This is to certify that TOP OF EXCHANGE LLC Monaghan Woodworks Inc.
has permission to Interior tenant fit-up of entire 2nd floor (permitted by 705)
AT 85 EXCHANGE ST (L 032 D004001)

Addendum #2 to Plans and Specifications For: Wall base and Metal door frames

85 EXCHANGE STREET, PORTLAND ME
 3RD FLOOR RENOVATIONS

Addendum #3 to Plans and Specifications For:

SKA-01
 REVISED RCP

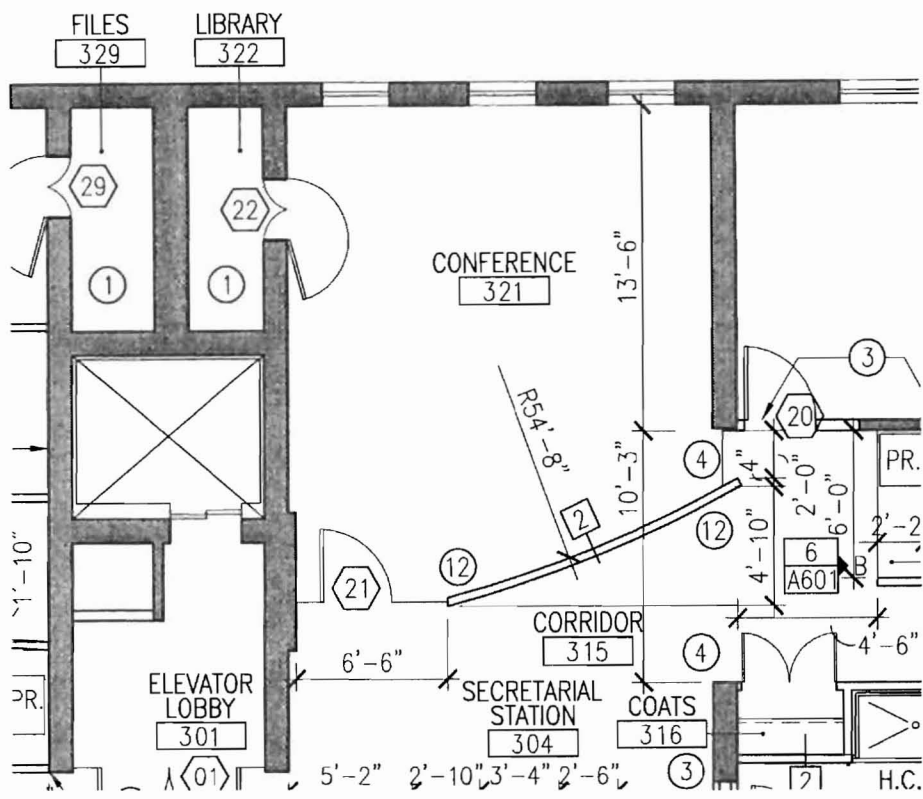
SKA-01: Delete curved GWB soffit and light cove in corridor #332 and file area #335. Provide additional lighting as indicated on sketch.

SKA-02
 REVISED CONF. RM. 321

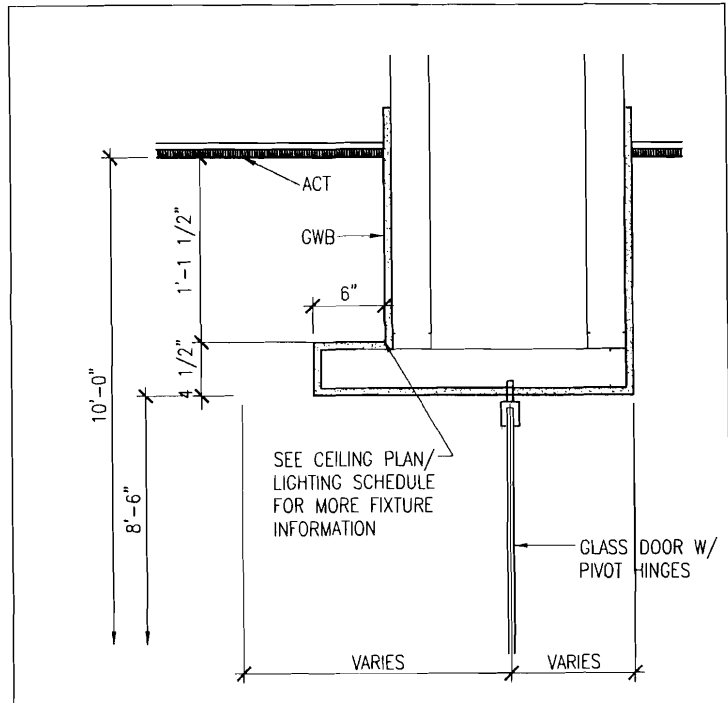
SKA-02: Delete GWB wing wall in conference room #321.

SKA-03
 ALTERNATE DETAILS

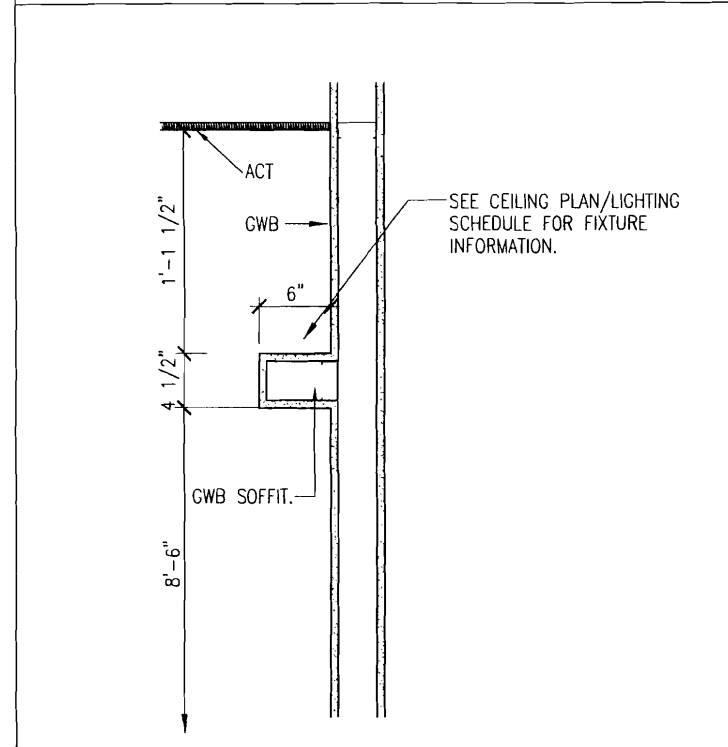
SKA-03: Alternate Detail, Provide a price to delete the GWB cove detail and cove lighting and provide the indicated detail.

PARTITION TYPES

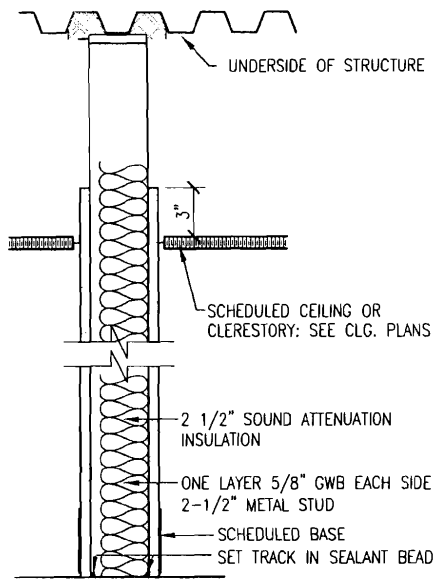
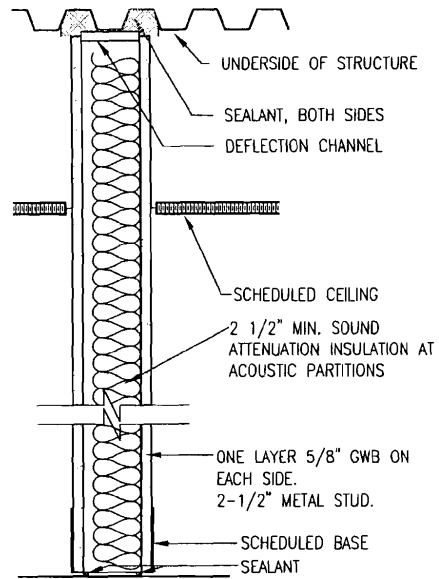
SKA-04: Partition types. Please note that all partitions between offices, new and existing, are to be type #2

SKA-05
 REVISED RCP

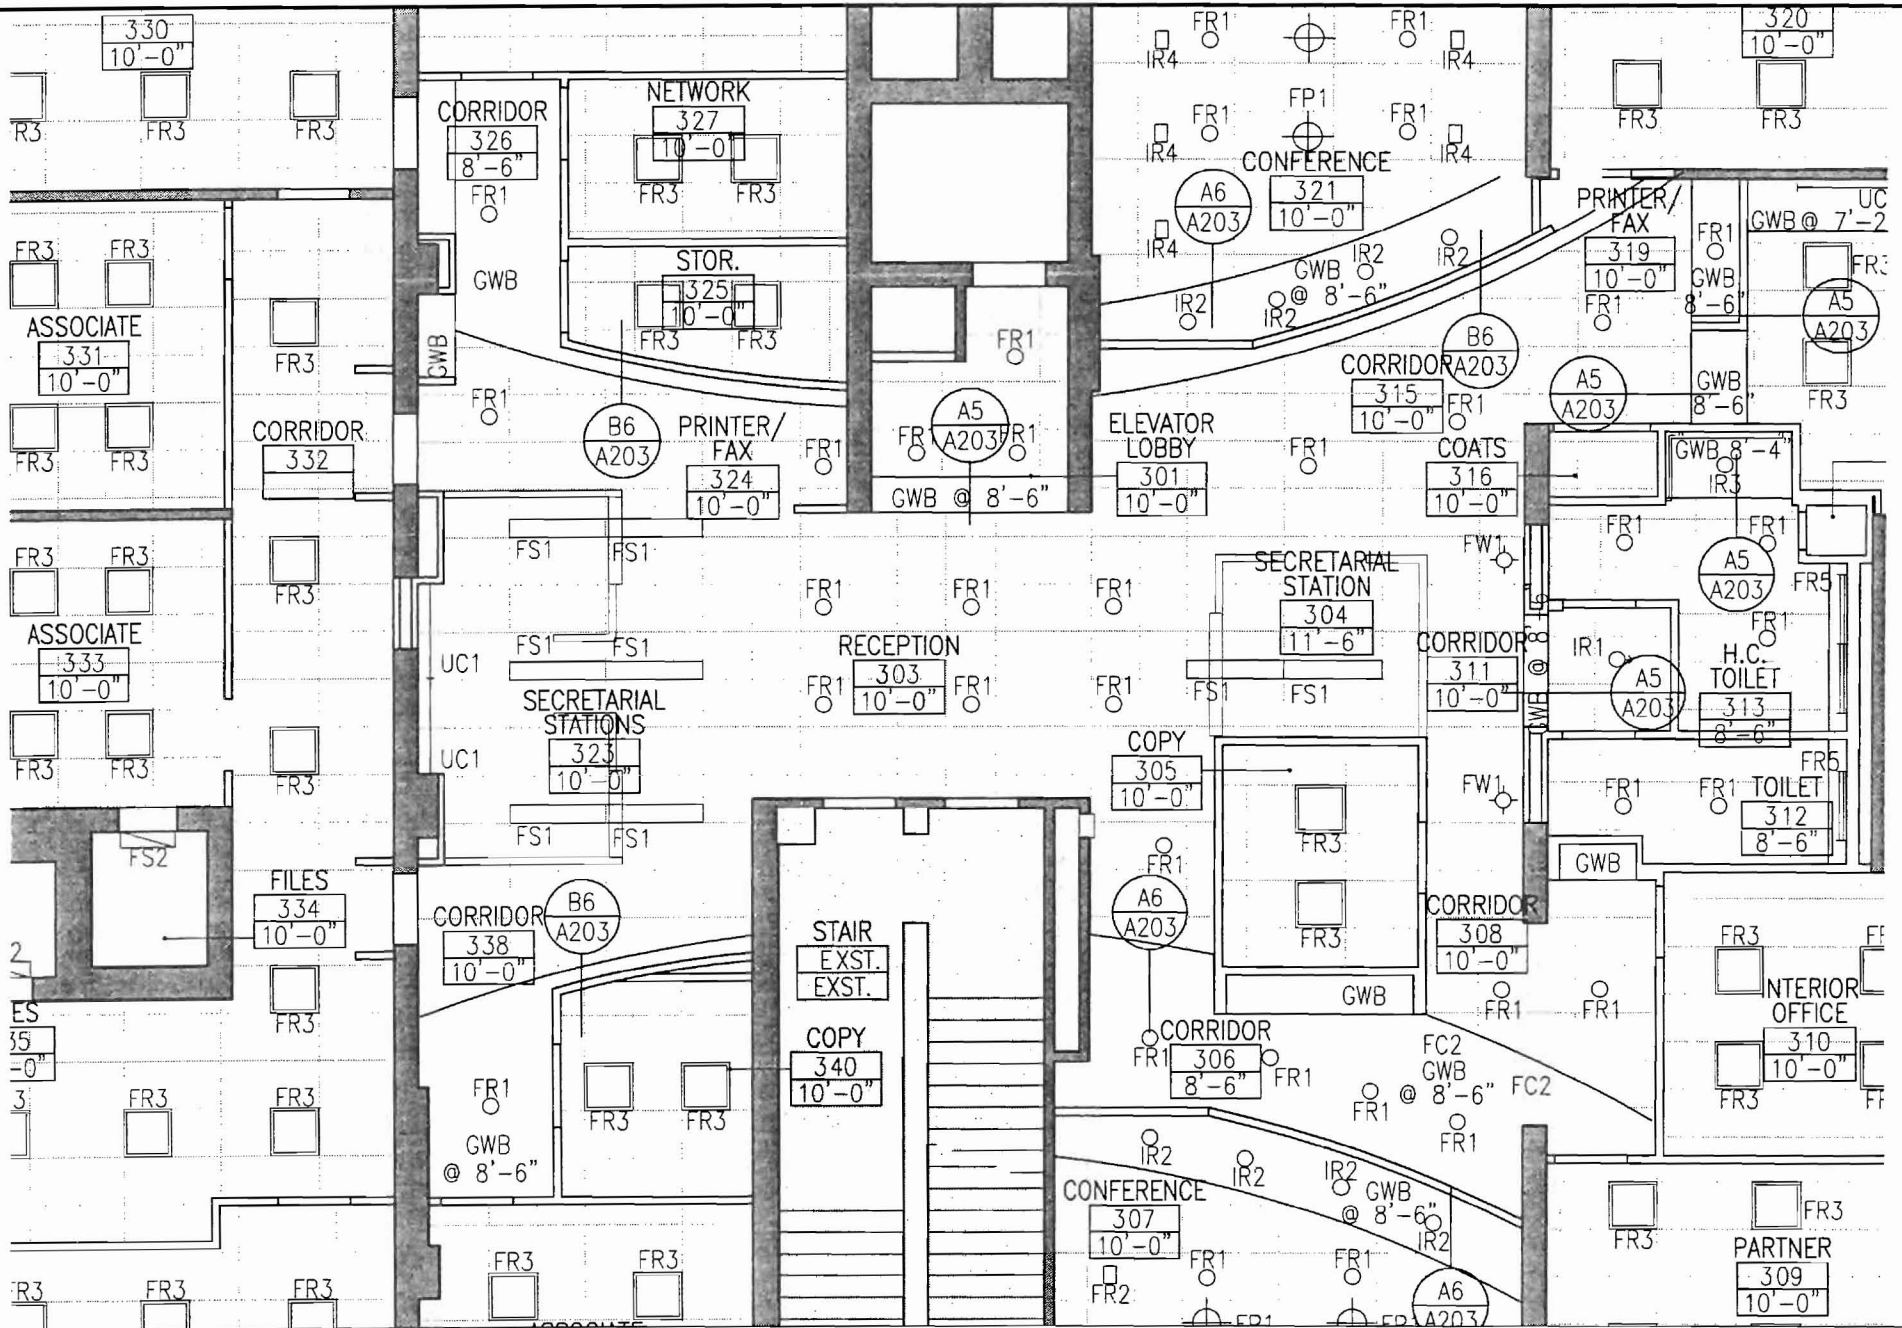
SKA-05: Alternate lighting, If the light cove is deleted along the curved GWB soffit additional light fixtures will need to be added to the ACT ceiling. Provide a price to provide the additional fixtures indicated on the sketch.

SKA-06
 ADA BATHROOMS

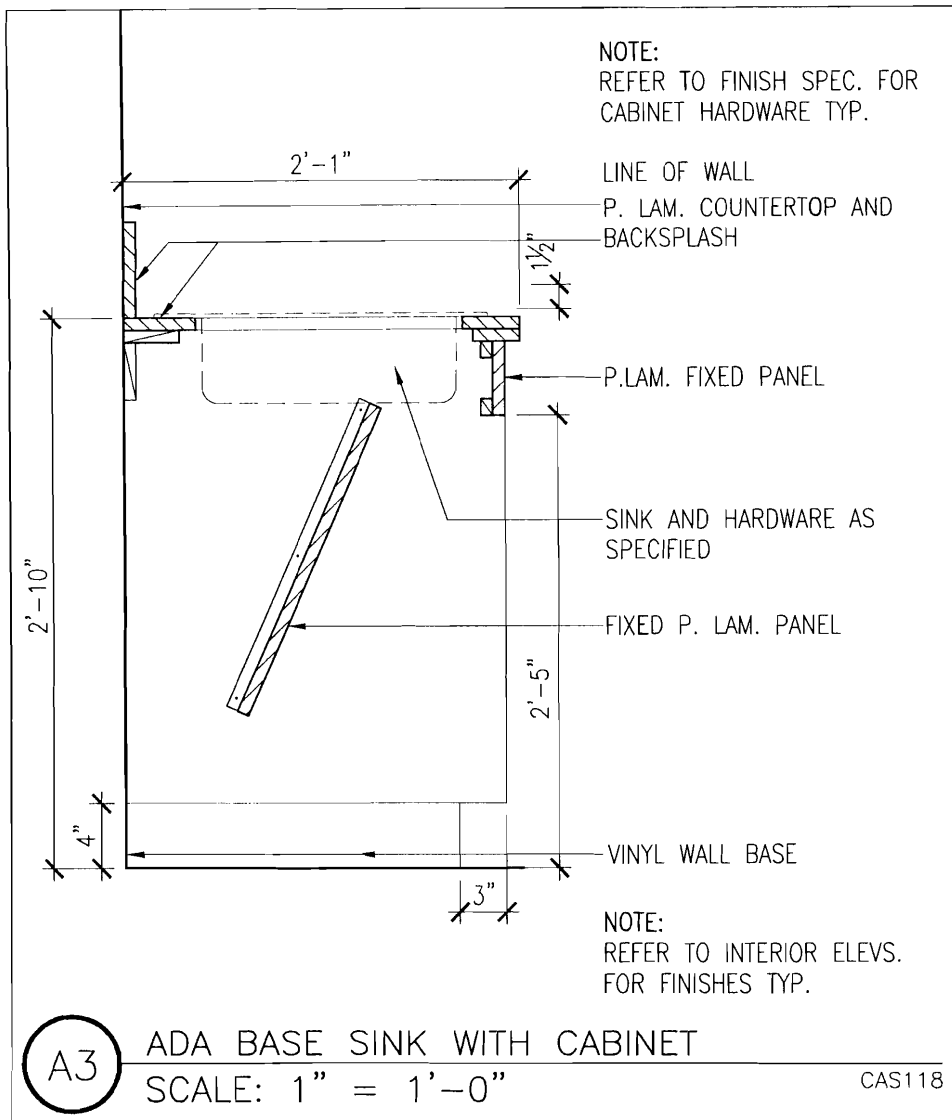
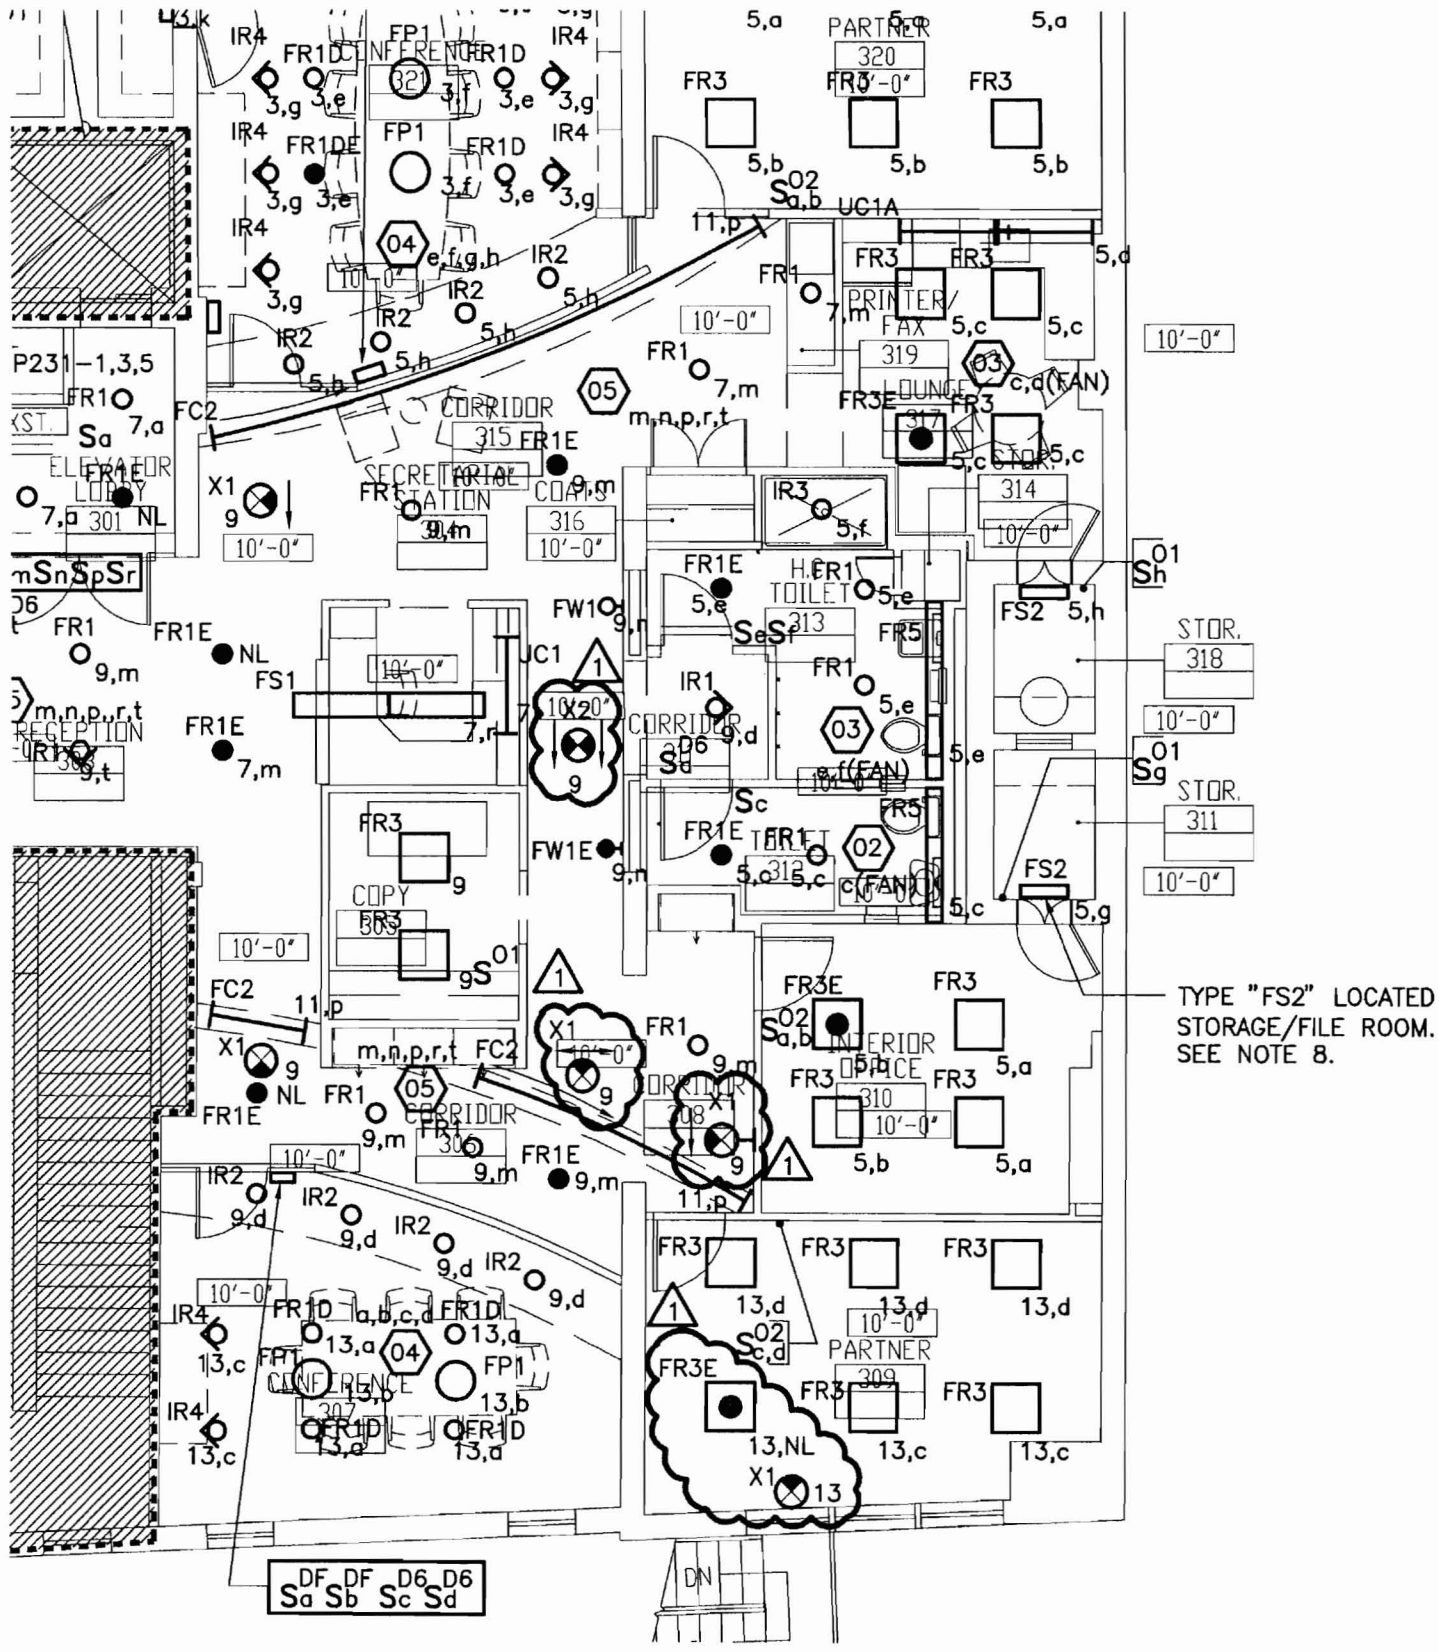
Bathroom revisions to comply with ADA codes.

NUMBER 26739 REVISION 1
 REFERENCE DRAWING E2.00

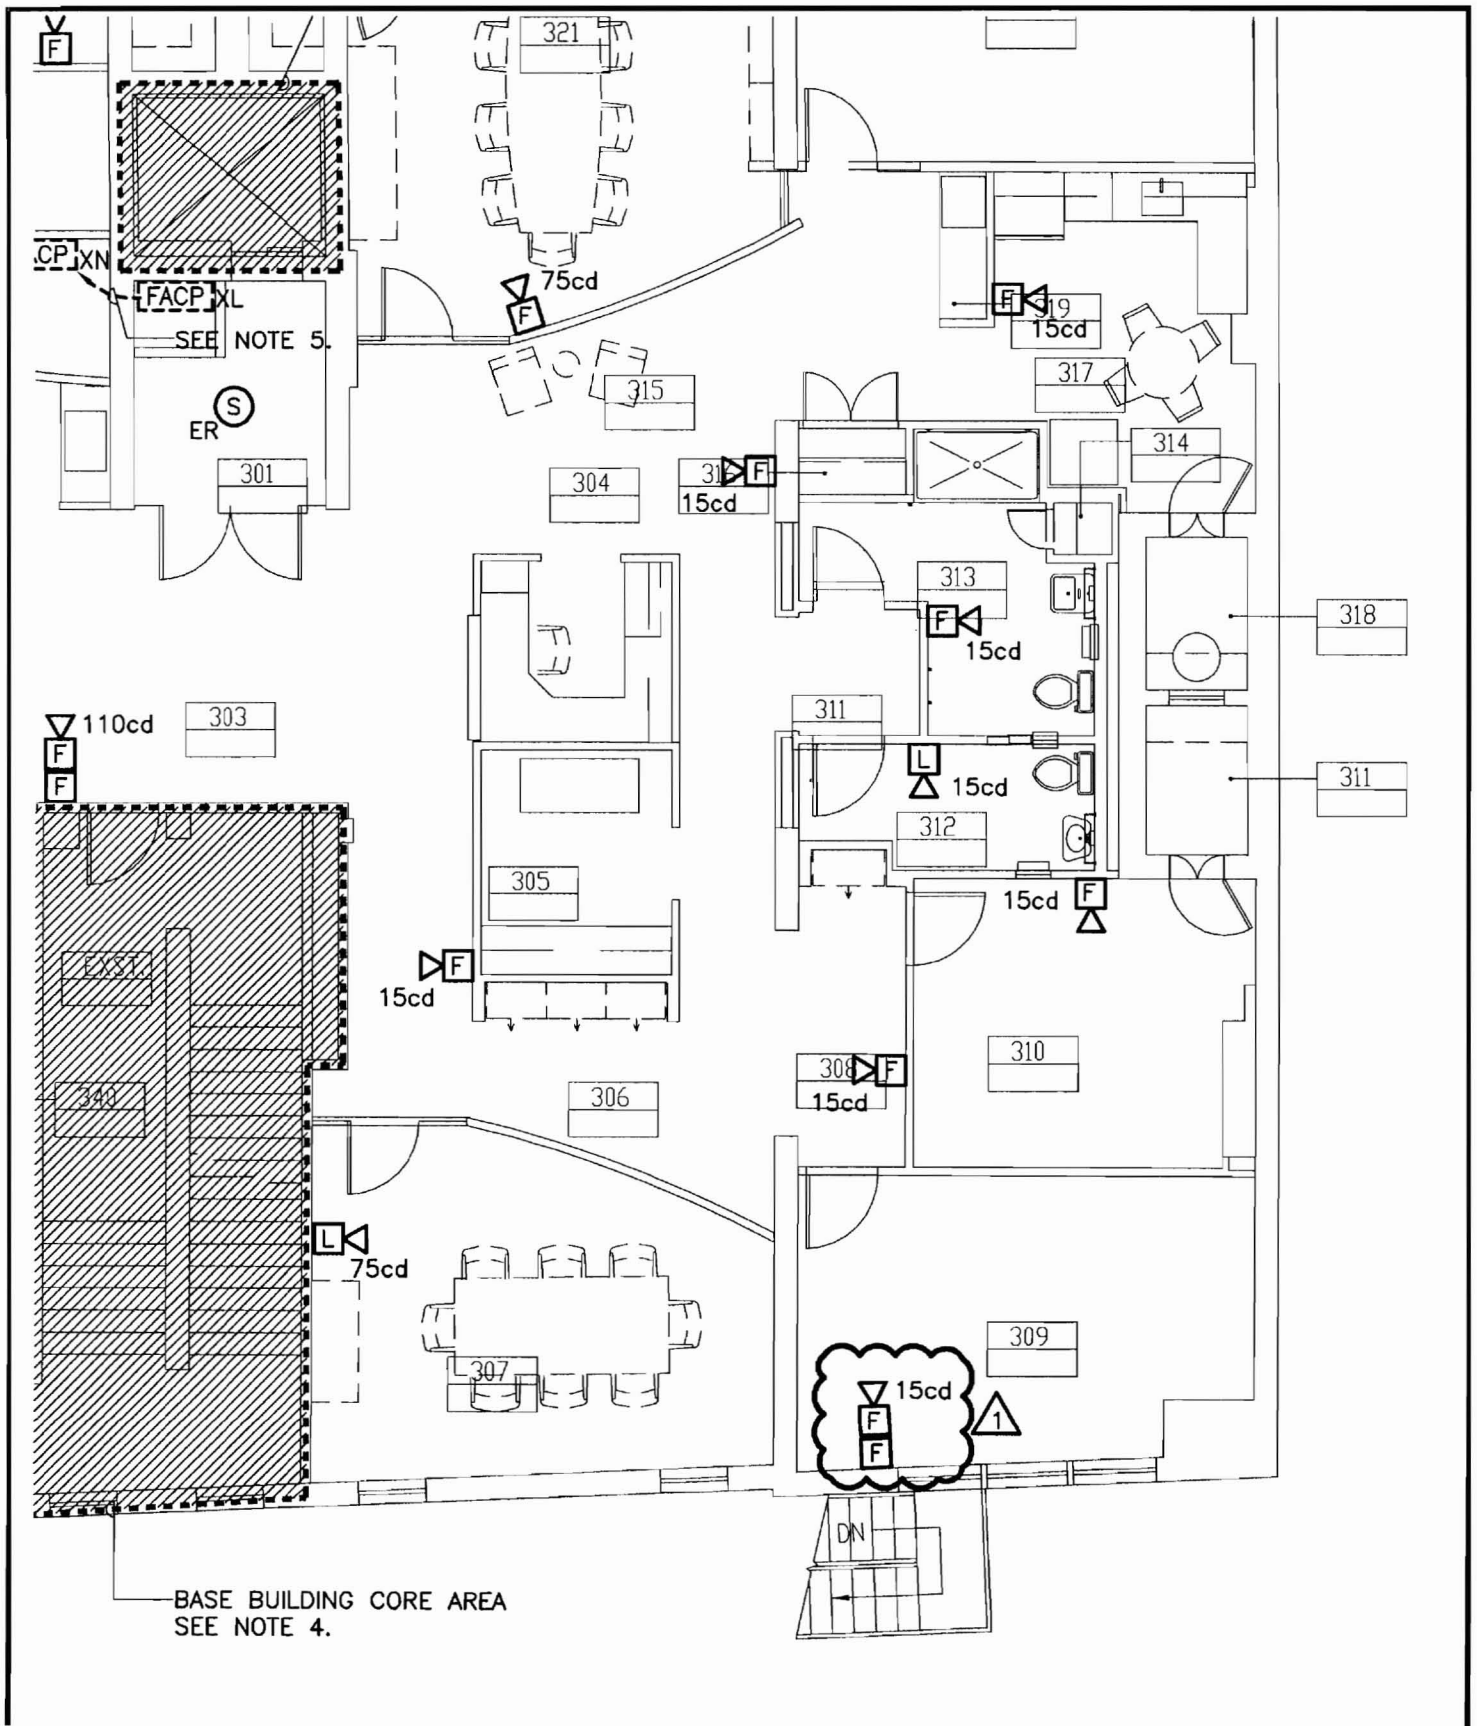
Revisions to life safety to clearly identify the fire escape as the second means of egress.
